STRUCTURAL CALCULATIONS FOR EXISTING SHORING SYSTEM

LNG Facility Modifications Project

Item No.	Copies	Date	Spec. Section	Submittal No.	Revision No.	Description of Submittal	Current Status
1	1	11/17/200	02160	1.01A	002	Title: Excavation Support Systems Desc: Excavation Support Systems coating	APP

REVISED SHORING DESIGN
FACILITY MODIFICATION
LNG SITE

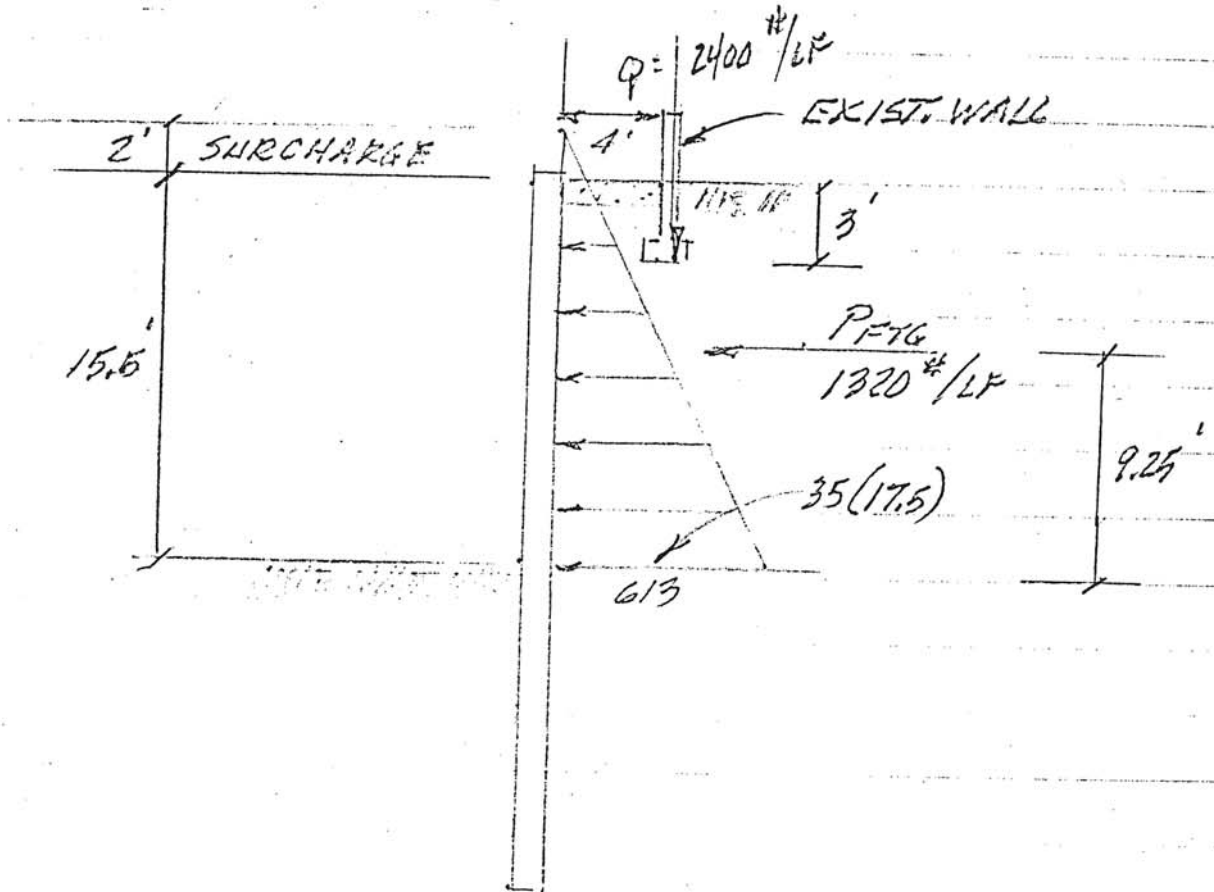
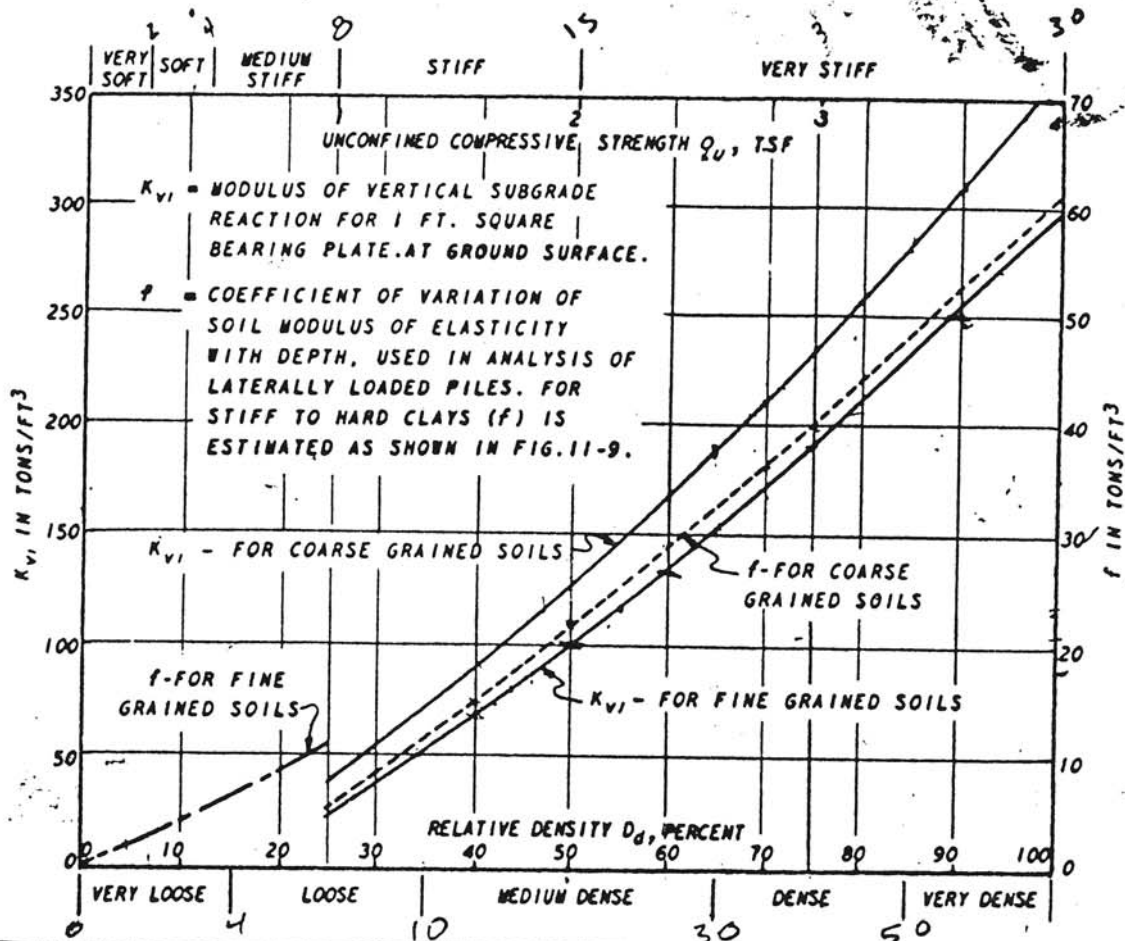
PER THE CORRODED THICKNESS OF
0.295" VS 0.335" FOR XZ 85 SHEET PILE,
THE MOMENT OF INERTIA WOULD DECREASE
FROM 212 in^4 TO 187 in^4 .. THE SECTION
MODULUS WOULD DECREASE TO 26.6 in^3 ..

PER SHEET 2 OF 2 OF MY CALCULATIONS
DATED 06/20/00:

$$S_{RQD} = 24 \text{ in}^3 < 26.6 \text{ in}^3$$

I received a call from Mike Dixon--the letter submitted is acceptable. Therefore, the sheeting calcs are acceptable. The pile without coating is accepted. We will return the letter as a submittal.

HENCE XZ 85 SHEET PILING OK
